TB 84 rev A

STANNAH LIFTS LTD

TECHNICAL BULLETIN

Subject : Pawl Device Retrofit Kit Modifications (further to bulletins TB82 & TB84)

Modification 2 - MRLi Lifts with Delta wired control panels manufactured before 30/11/2006

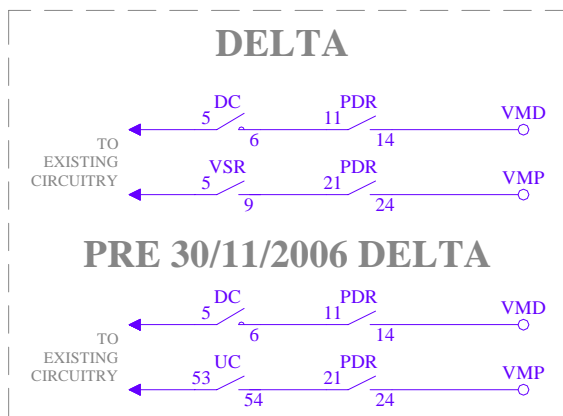
On Delta wired lifts manufactured before 30th November 2006, the ‘VSR’ contact will not be present. Instead wire ‘PDR’ contact 21 to ‘UC’ contact 54, as detailed below.

Kits dispatched after 14-09-2009 included revised drawings incorporating Modification 2.
